Rezoning Transportation Analysis

Petition Number: 2019-029

General Location Identifier: 12703509

Date	Description
03-21-2019	First Review
05-07-2019	Second Review
05-16-2019	Third Review

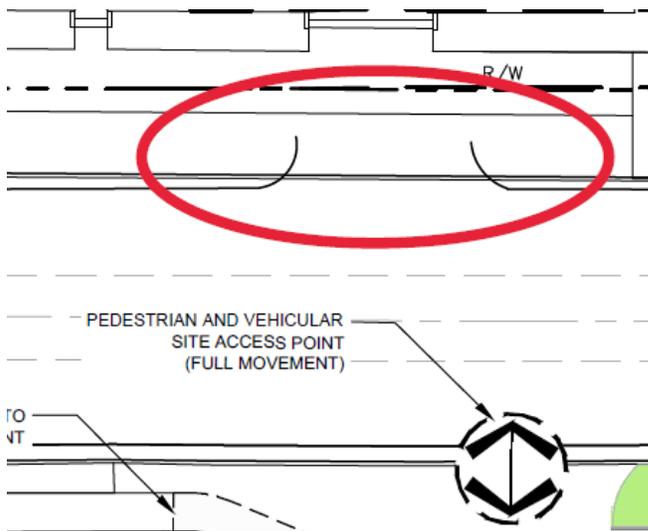
3. ~~The petitioner should revise the site plan to include all existing driveways along East 7th Street and North Caswell Road in the existing right of way. CDOT cannot verify the location of the driveway shown in the picture below.~~
